STAFF REPORT: 10/9/2024 MEETING

ADDRESS: 2061 LONGFELLOW

APPLICATION NO: #HDC-2024-00532

SCOPE: ERECT GARAGE AND REHABILITATE DWELLING

Proposed site plan/porch plan.

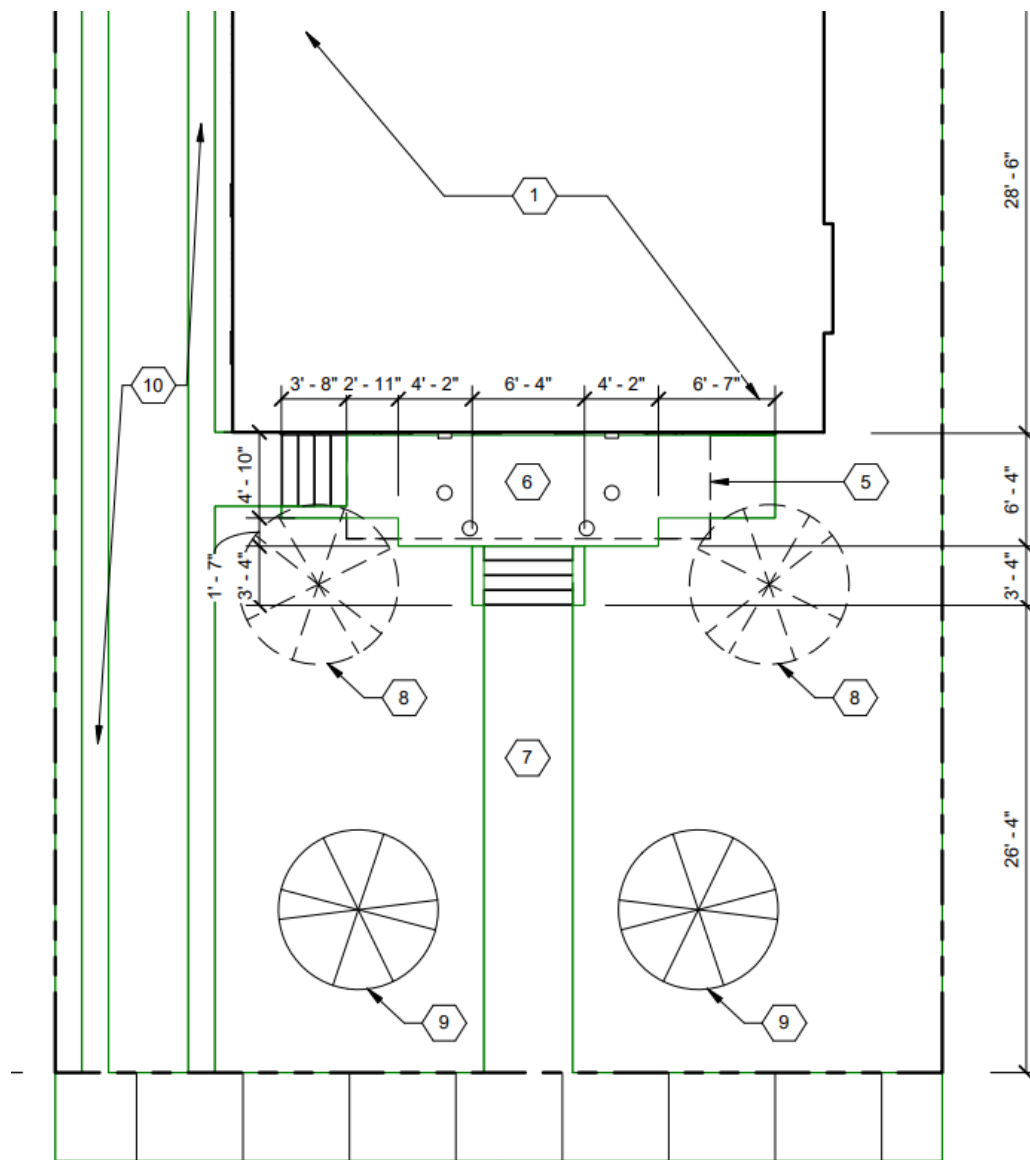
Note that a terrace does currently exist at the property's front yard, directly north of the front façade/front porch (see below photos). The concrete walkway which was removed from the front yard without HDC approval included a single step directly to the south of its junction with the public sidewalk and a three-step rise with a landing to the direct north of a single porch step. The current application appears to indicate that the existing terrace will be removed as it proposes a straight walkway which leads from the sidewalk to the porch steps (four steps total versus the single step which marked the original porch that was removed without HDC approval). It is staff's opinion that the existing terrace is a distinctive, character-defining landscape feature that should be retained. Staff also recommends that the original porch and front yard walkway step configuration/number be replicated in order to accommodate the terrace's maintenance.

- The front yard terrace is a distinctive character-defining feature of the property and therefore the Standards require that it be retained. The original porch and front yard walkway which were removed without HDC approval were also distinctive character-defining features of the property and should be replicated to maintain the property's historic appearance/character and to support the retention of the terrace.
- Per the above, the existing character defining leaded glass window at the rear wall proposed for removal does appear to be deteriorated beyond repair and the new casement window proposed to replace the character defining leaded glass window at the rear wall

- The terraced landform at the front yard shall be retained/shall not be lowered or flattened. The new front yard walkway and porch steps shall be redesigned to replicate those which were removed without HDC approval. HDC staff shall be afforded the opportunity to review and approve the final design prior to the issuance of the permit.

Rear wall, current appearance. Photo by applicant

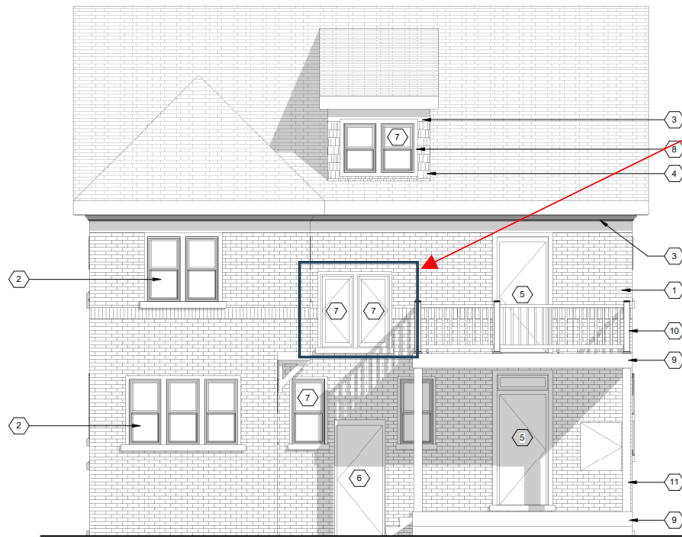
- The application proposes to replace one existing distinctive character-defining leaded glass wood casement window at the rear wall, second story with a new single lite aluminum-clad wood casement window. Also, the application proposes to install a new aluminum-clad wood casement window to replace a second leaded glass wood casement window that was removed without HDC approval (see below). Note that the application does not provide evidence that the leaded glass window which is proposed for replacement is deteriorated beyond repair. Additionally, the replacement window does not represent an adequate replication of the leaded glass window that was removed without HDC approval. It is staff's opinion that these work items conflict with Secretary of the Interior Standards for Rehabilitation #6, which states the following:

This window is proposed for replacement

A leaded glass window at this location was removed without approval. The applicant proposed to install a single lite aluminum-clad wood casement window in this opening

which was removed without HDC approval is not an adequate replication. These work items do not meet the Standards

- The one existing distinctive character-defining wood casement window (with diamond patterned lead coming)at the rear wall, second story proposed for replacement shall be retained and repaired.

- The new window which shall be installed at the rear wall, second story to replace a casement window with diamond patterned lead coming that was removed without HDC approval shall display a lite configuration and material which adequately replicates the window that was originally present within the opening. HDC staff shall be afforded the opportunity to review and approve the final window selection.
